The Commission has issued the enclosed Amendment Nos. 15 and 11 to Facility License Nos. DPR-29 and DPR-30 for Units 1 and 2 of the Quad Cities Nuclear Power Station. These amendments include Change No. 26 to the Technical Specifications and is in response to Commonwealth Edison's request dated December 13, 1974, as supplemented December 20, 1974, January 27, 1975, March 14 and 27, 1975, and April 9, 1975. These amendments also include your request dated May 15, 1974, as supplemented by filings dated October 22 and December 5, 1974.

These amendments (1) incorporate operating limits in the Technical Specifications based on the new General Electric Thermal Analysis Basis (GETAB), and (2) authorize changes to the APRM flux scram and APRM Rod Block Limits.

QUAD CITIES NUCLEAR POWER STATION UNIT 1

CHANGE NO. 26 TO THE TECHNICAL SPECIFICATIONS

Figure 2.1-2
 PEAK LHGR VERSUS CORE THERMAL POWER
 FOR A LIMITING TOTAL PEAKING FACTOR

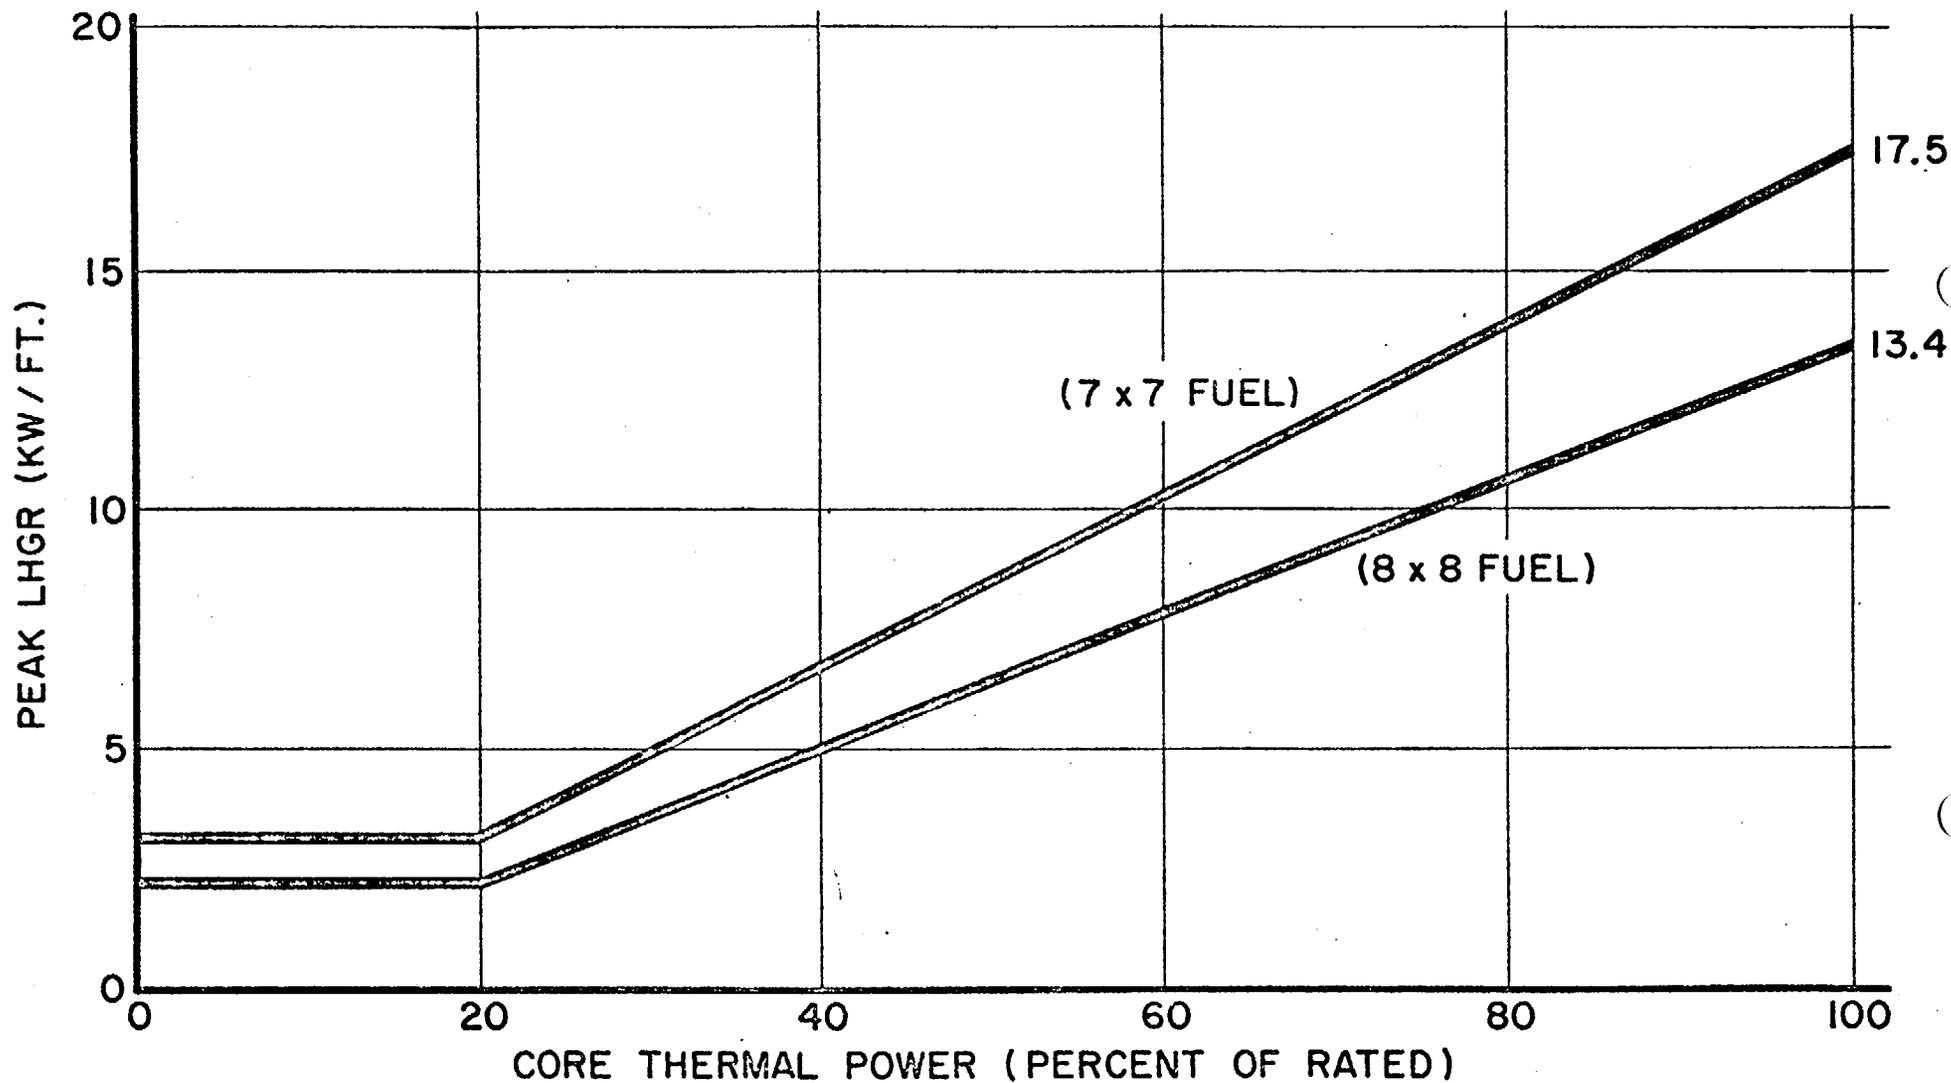
TPF = LTPF unless the combination of power and peak LHGR is above the curve in Figure 2.1-2 at which point the actual peaking factor value shall be used.

terms of heat flux and base the required settings on the design linear heat generation rates of 17.5 and 13.4 kw/ft for 7 x 7 and 8 x 8 fuel respectively. Figure 2.1.2 would be changed from a linear plot of peak heat flux versus power to a plot of peak LHGR versus power for 7 x 7 and for 8 x 8 fuel. For power levels between zero and 20% of rated core thermal power, peak LHGR rates of 3.5 and 2.68 kw/ft rather than total peaking factors are specified for 7 x 7 and for 8 x 8 fuel respectively. Below these LHGR levels fuel cladding damage because of a departure from nucleate boiling would not be expected and therefore these limiting safety system settings are acceptable.

FIGURE 2.1-3 APRM FLOW BIAS SCRAM RELATIONSHIP TO NORMAL OPERATING CONDITIONS

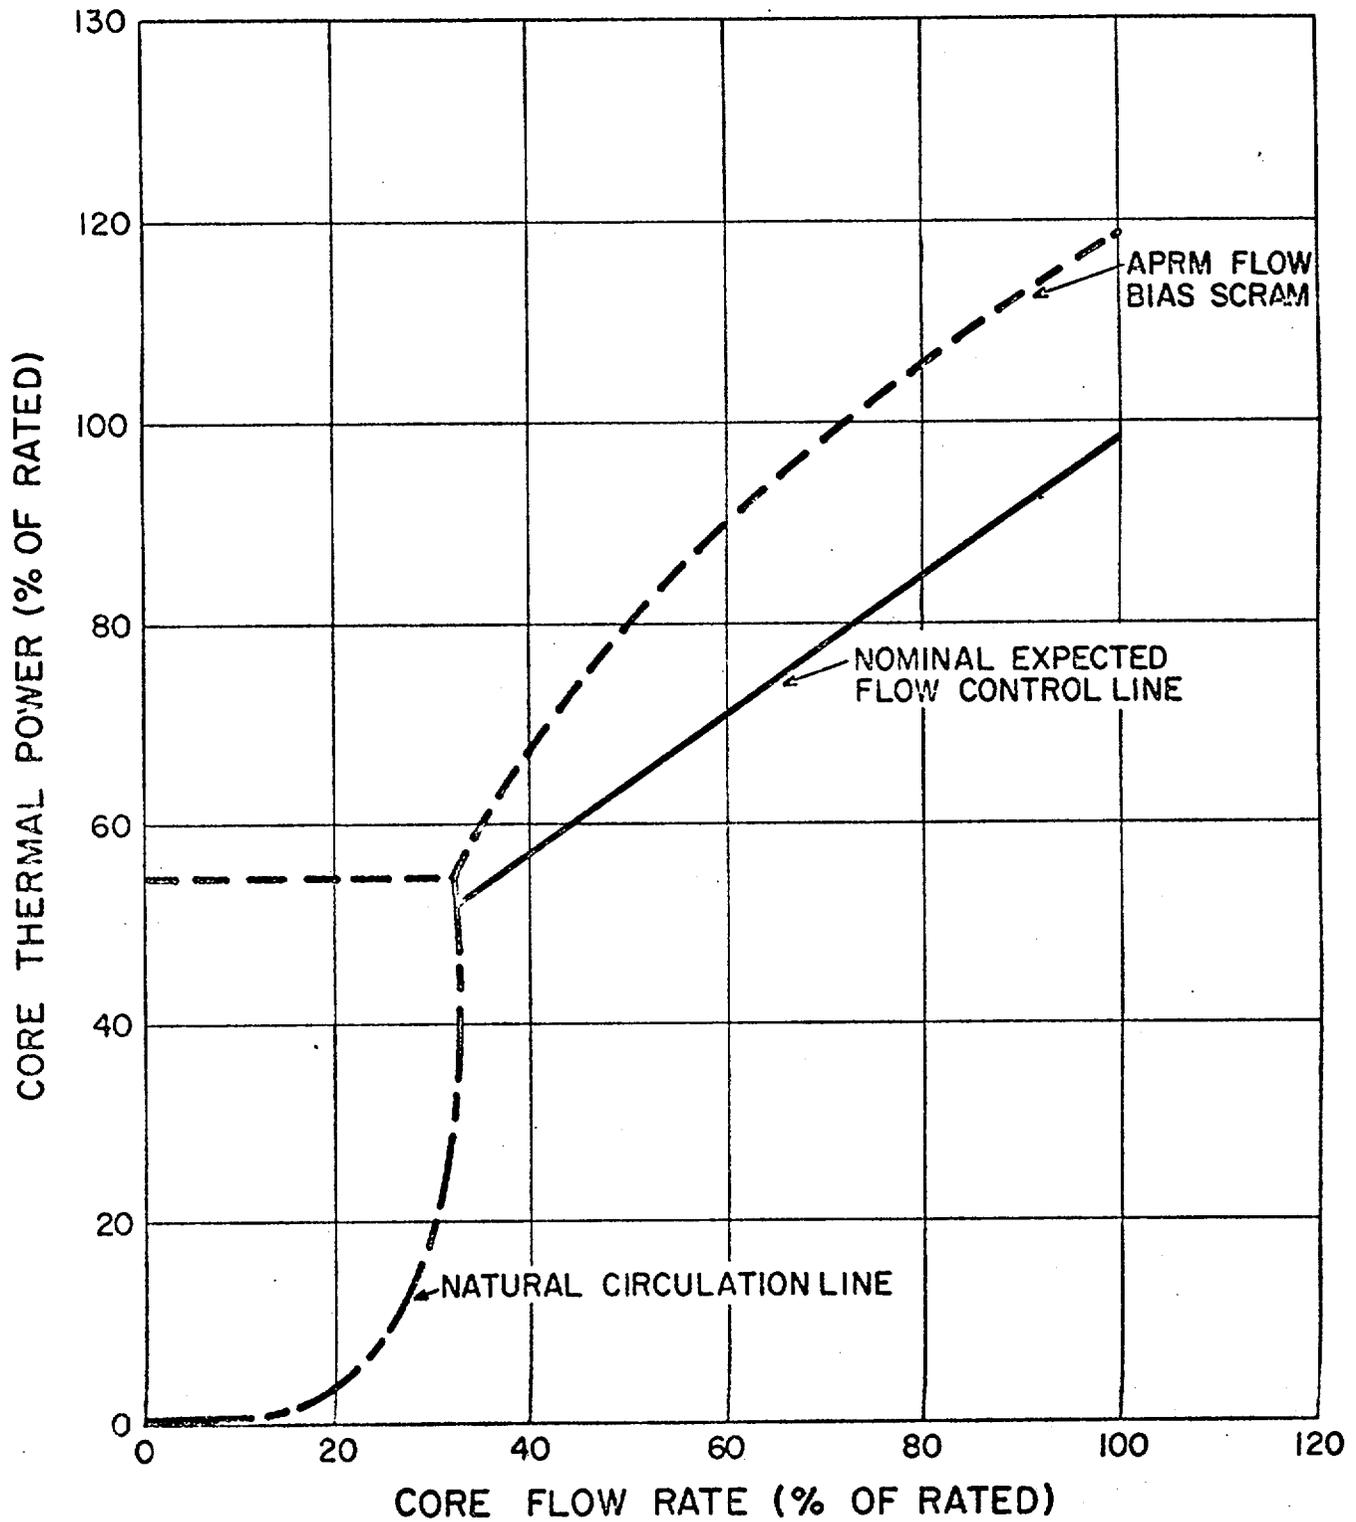
boiling divided by the actual bundle power. The minimum value of this ratio for any bundle in the core is the minimum critical power ratio (MCPR). It is assumed that the plant operation is controlled to the nominal protective setpoints via the instrumented variables. (Figure 2.1-3).

FIGURE 3.5-2 K_f FACTOR

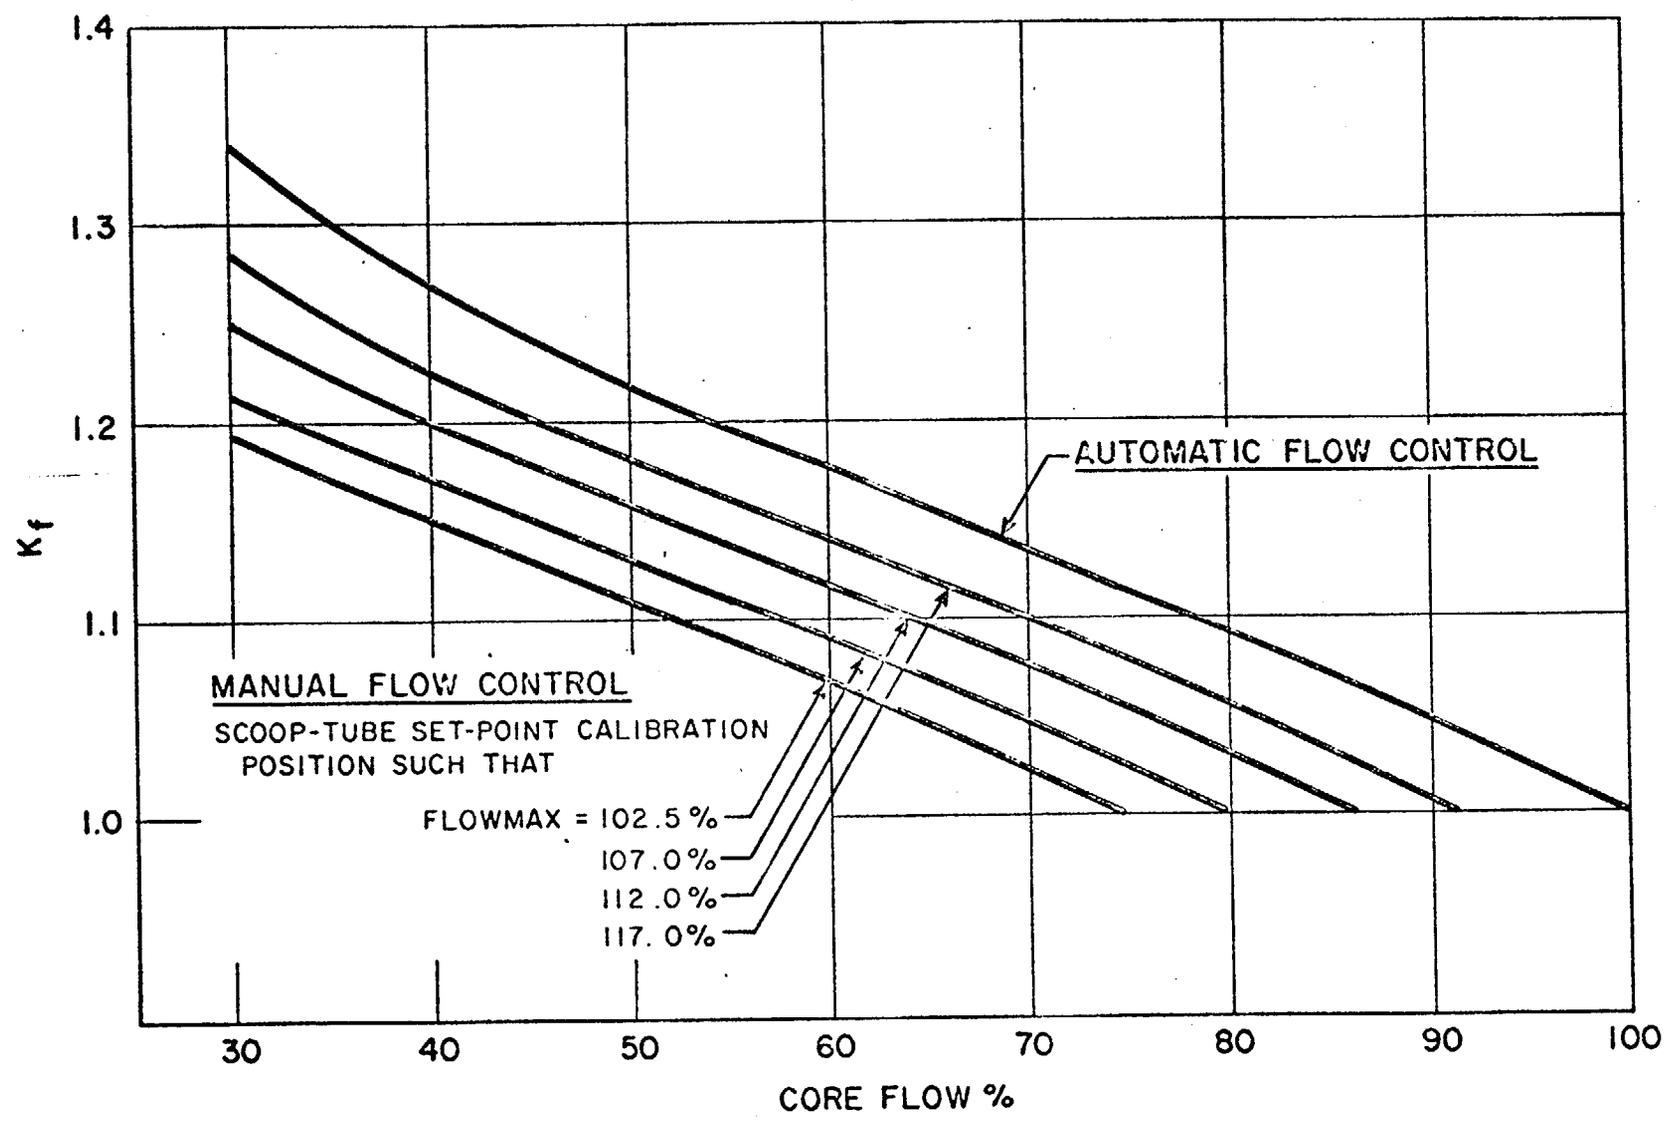
at rated power and flow. For core flows other than rated, these nominal values of MCPR shall be increased by a factor of K_f , where K_f is as shown in Figure 3.5-2.
